Process Sheet

Customer	CU-DAR001 Dart Helicopters Services		Drawing Name	WEARPAD		
Job Number	31419					
Estimate Number	12782					
P.O. Number	N/A		Part Number	D35643		
This Issue	3/21/2007	S.O. No.	N/A	Drawing Number	D3564 REV A	
Prsht Rev.	NC			Project Number	N/A	
First Issue	N/A	Type	SMALL /MED FAB	Drawing Revision	A	
Previous Run	31134		Material	N/A		
Written By			Due Date	3/30/2007	Qty:	10
Checked & Approved By	JAN 07.03.22		Um:	Each		
Comment	Est Rev:A New Issue 07-03-08 ec

A	06.12.18	NEW ISSUE
DESIGN	DRAWN BY	DART
P4	P4	DART AEROSPACE LTD. HAWKSBURY, ONTARIO, CANADA
CHECKED	APPROVED	DRAWING NO.
		D3564
DATE		REV. A
06.12.18		SHEET 1 OF 2
		SCALE
		1:8
		TITLE
		WEARSHOE

From: Peter Hum [phum@dartaero.com]
Sent: April 13, 2007 9:11 AM
To: 'Chris Provencal'; 'Jason Murdoch'; 'Bill Beckett (Bill Beckett)'; cbell@dartaero.com; 'Dale Trepanier'; 'Dan Stow (Dan Stow)'; 'Eric Charbonneau'; 'Jean Luc Menard'; 'Kim Johnston (Kim Johnston)'; 'Leanne Elsliger'; 'Linda Lacelle (Linda Lacelle)'; 'Marc Bellavance'; 'Serge Shahbazian'; 'Susanne Sheldon (Susanne Sheldon)'
Subject: UNDER REVIEW D3535, D3537, D3564 WEARPLATES/WEARPADS

D3564-1F FLAT PATTERN

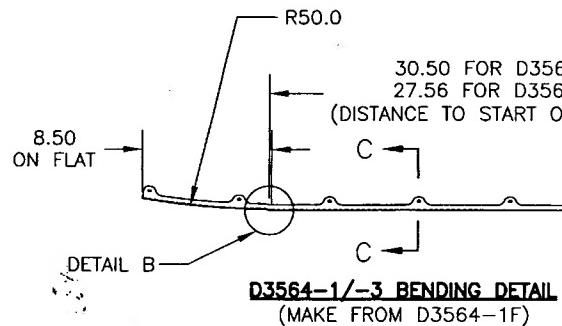
NCR:		WORK ORDER NON-CONFORMANCE (NCR)						
DATE	STEP	Description of NC Section A	Corrective Action Section B			Verification Section C	Approval Chief Eng	Approval QC Inspector
			Initial Chief Eng	Action Description Chief Eng	Sign & Date			
07/04/18	7	TAB WILL NOT FIT SKIDTUBE <i>RJL por 07.04.18 WSI 042</i>	<i>OPEN TABS BY 0.060"</i> <i>SEE ATTACHED</i>	<i>FF 07/04/18</i>	<i>07/04/18</i>			<i>J 07/04/18 07/04/18 07/04/18</i>

I can't understand why we are just finding out now that the flat pattern is 0.100" to 0.120" too narrow the day before we want to ship the parts. It seems to me this could have been tried with one small prototype piece on a couple sets of holes before we programmed and cut multiple parts on the waterjet. When I sign the drawings, I am assuming all of this stuff has been worked out. I would guess that the programmers are making the same assumption.

For future shipments the flat pattern will need to be updated.

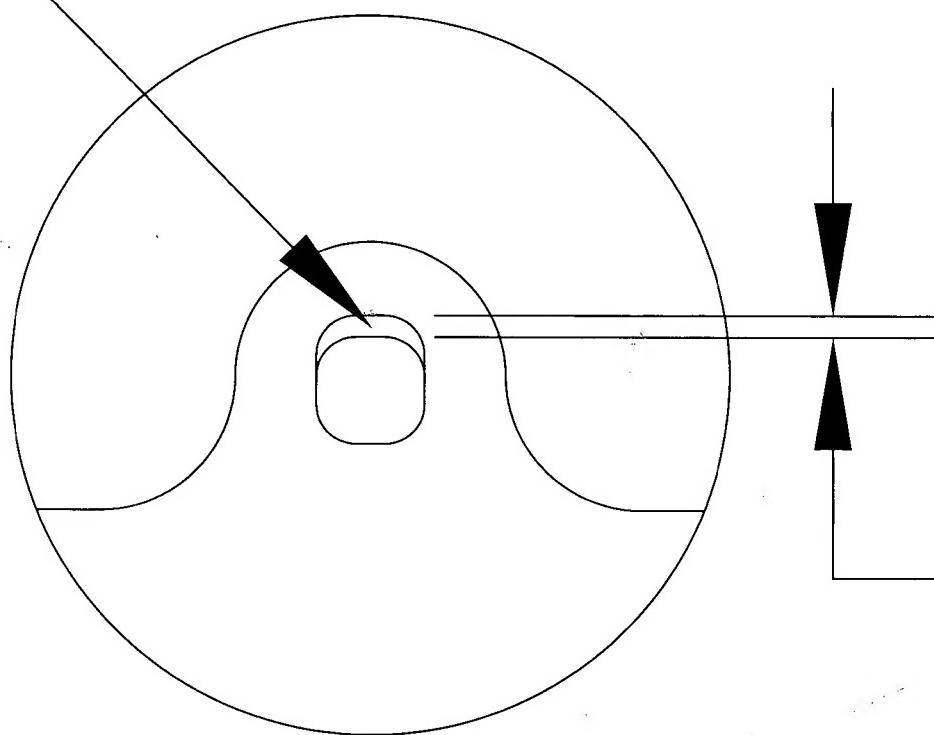
Engineering has discovered a problem with the tabs not being wide enough when the gasket is installed underneath.

• OPEN TABS 0.060''
OUTBOARD TO ALLOW INSTALLATION

REMOVE
MATERIAL
